San Francisco Peninsula Rail Program

Memorandum

To: Executive Steering Committee
From: Alfonso Rodriguez, DTX Project Director
Stephen Polechronis, Program Manager
Date: October 22, 2021
Re: Item 6, Informational Item
Design Development Configuration Changes
for the Downtown Rail Extension

Concept C Reduced - Third Track Reduction

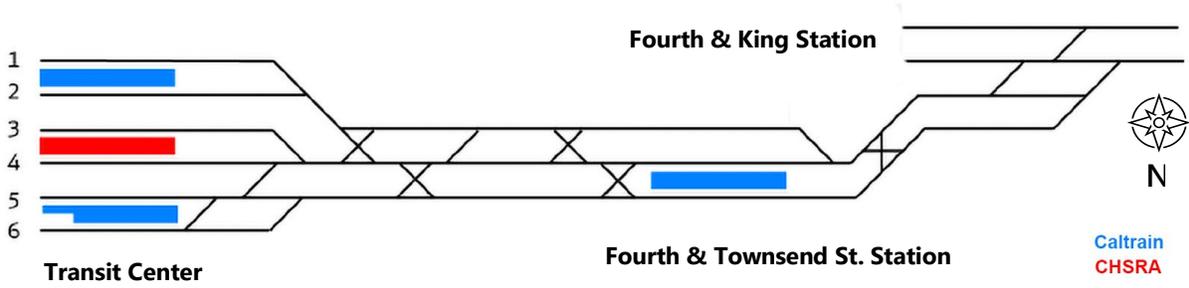
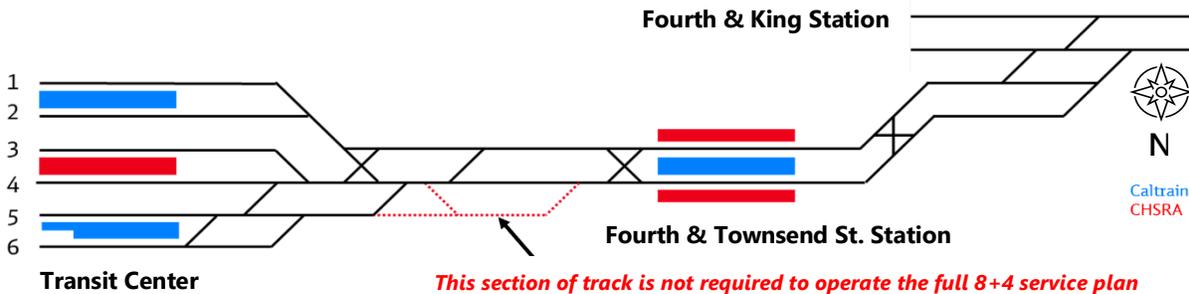
Description: The baseline concept (See Attachment 1, Baseline Concept) included a three-track tunnel configuration beginning just west (outbound) of the Fourth and Townsend Station along Townsend and Second Streets all the way to the throat section in the vicinity of Tehama Street. Through the aforementioned Operations Analysis and proposed reconfiguration of the Fourth and Townsend Station layout (described below), an alternative operating scenario was developed and tested with a reduced three track configuration utilizing an extended two track section of tunnel in conjunction with the proposed Fourth and Townsend Station layout. In this configuration, the three track section need not begin until approximately mid-way between Harrison and Folsom Streets along 2nd Street (see Attachment 1, Third Track Reduction). This configuration does not change the project configuration inbound of this new three-track section, including the throat structure where the three tracks are expanded to six to access the six-track transit center layout.

Implications: Rail Operations consistent with the operators' service plans (8 peak hour each direction Caltrain trains and 4 peak hour each direction CHSRA trains) has been modeled under normal, perturbed, and contingency scenarios. In all cases, performance was consistent with operators' established service standards.

Because the construction of a reduced three track tunnel section would result in less excavation and construction material, and presumably a shorter construction schedule, environmental effects are presumed to be reduced and would likely require only an environmental technical memorandum to document the configuration change. This approach to National Environmental Policy Act (NEPA) has been informally reviewed with the Federal Transit Administration and favorably received although formal approval will be required during the Capital Investment Grants Project Development process, planned to commence in the next few months.

The reduced three track configuration was also analyzed in a through running configuration through a sketch-level planning study. No reduction in through-put at the transit center was observed.

Capital Cost Change: Compared to the baseline project (as defined in the FSEIS/EIR, adoption of this configuration change is estimated to result in a cost reduction of \$200,000,000, escalated to a mid-point of construction of 2027 and includes soft costs, contingency, and reserves.

Concept C Fourth and Townsend St. Station Modifications

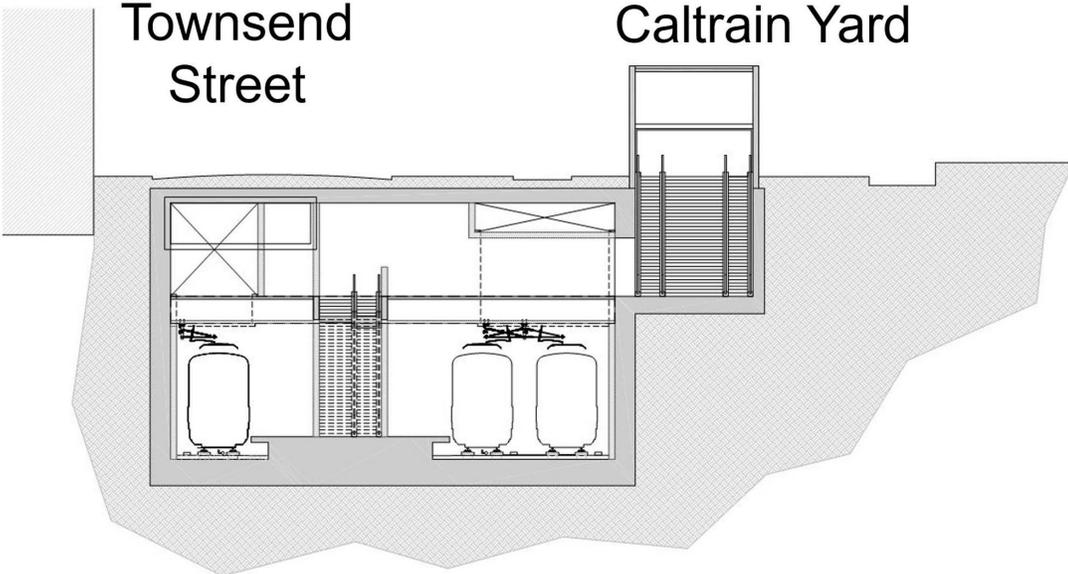
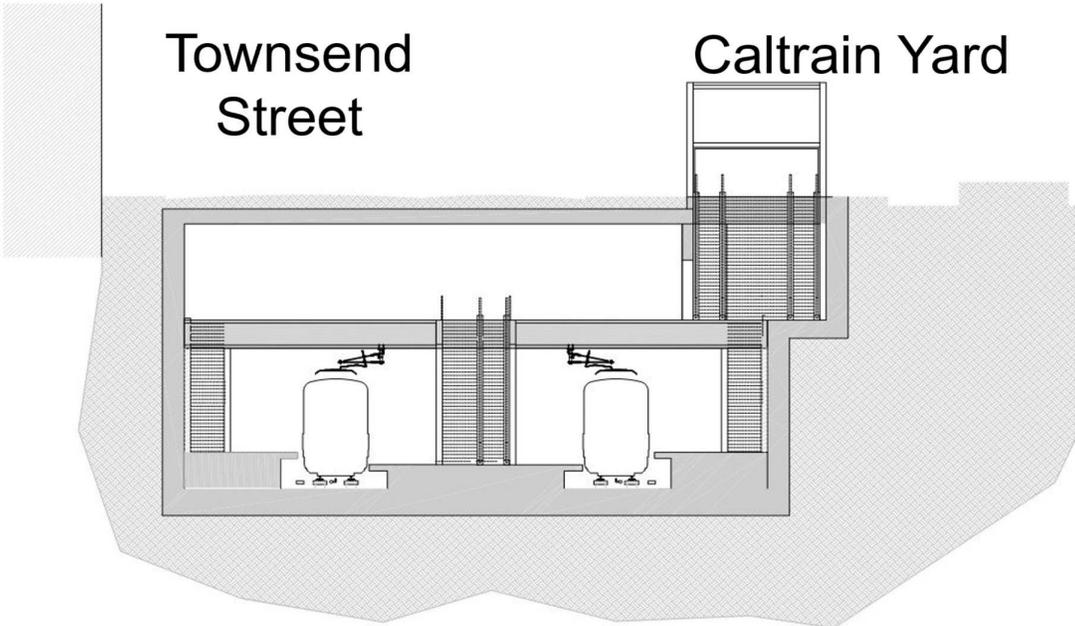
Description: The baseline concept (see Attachment 2, Transverse Section - Baseline Concept and Attachment 2, Aerial Plan View – Baseline Concept) includes a three track single Caltrain platform configuration with CHSRA trains running through the station without stopping. No platform for CHSRA is provided in the Baseline Concept. Since the time this concept was developed, CHSRA has determined that they will serve the Fourth and Townsend Street Station and thus require platform and other limited passenger facilities. During the operations analyses, several alternative layouts for the station were evaluated to accommodate both Caltrain and CHSRA service at the operators' service plans (8 peak hour each direction Caltrain trains and 4 peak hour each direction CHSRA trains). The optimum solution was determined to include two tracks serving one center platform for Caltrain passengers and two side platforms servicing CHSRA passengers (see Attachment 2, Transverse Section – Station Concept C and Attachment 2, Aerial Plan View – Station Concept C).

Implications: The Fourth and Townsend Street Station Concept C arrangement permits service for both operators with the desirable dedicated platforms and results in the elimination of conflicting inbound and outbound train movements in the throat section, enabling the significant reduction of third track as discussed above.

This proposed arrangement does increase the width of the station box, encroaching an additional approximate 17 feet into the Caltrain Fourth and King Yard, with some additional encroachment at the vertical circulation and ventilation structures along the station length. However, the relative impacts are reduced by the fact that the baseline concept includes several “bump outs” required for passenger access, emergency egress, and ventilation structures that extend beyond the station box and at the surface. Since Station Concept C largely incorporates these structures into the station box, the net additional encroachment is .16 acres. (see Attachment 2, Street Level Plan View – Baseline Concept and Attachment 2, Station – Concept C, and Summary Table).

The environmental effects associated with this configuration change include additional excavation and disposal of spoil material and an increase in the delivery of construction material, both due to the increased size of the station box. However, these are similar effects to those already reported in the approved FSEIS/EIR. As mentioned above, there is further encroachment for this proposed alternative under the Caltrain Yard as compared to that described in the FSEIS/EIR.

Capital Cost Change: Compared to the baseline project (as defined in the FSEIS/EIR), adoption of this configuration change is estimated to result in a cost increase of \$150,000,000, escalated to a mid-point of construction of 2027 and includes soft costs, contingency, and reserves.
